### Kit 23-3001 S

**SUBJECT:** PITOT AND STATIC SYSTEM, IMPROVED STATIC AIR FITTINGS

**AIRCRAFT AFFECTED:** BEECHCRAFT Musketeers, Models 23, A23, A23A, serials M-1 through M-1155; Model A23-19, serials MB-1 through MB-377; Model A23-24, serials MA-1 through MA-353.

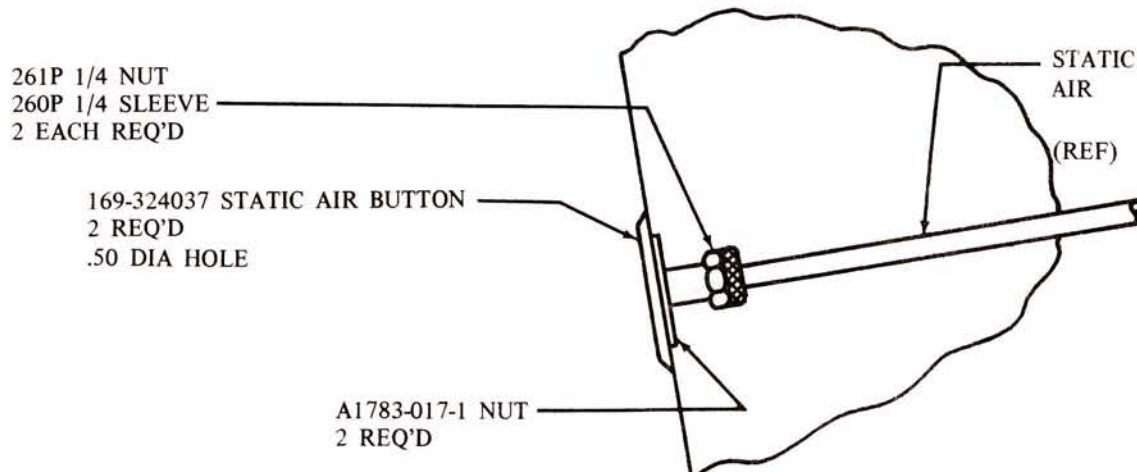
Current production BEECHCRAFT Musketeers have new, improved static air fittings. The new fittings have three holes angled into the body to reduce the probability of moisture entering the static tubes during inclement weather.

3. Ream the holes to .50 inch diameter. Burr and prime the bare metal.

4. With an assistant outside the airplane to hold the new fittings in place, press the new plate nuts over the shanks of the static fittings from inside the airplane.

5. Slip one new tube nut and sleeve over the end of each static tube. Screw the nuts onto the static fittings, locking the sleeves firmly in place. (See the illustration for a schematic of the new installation.)
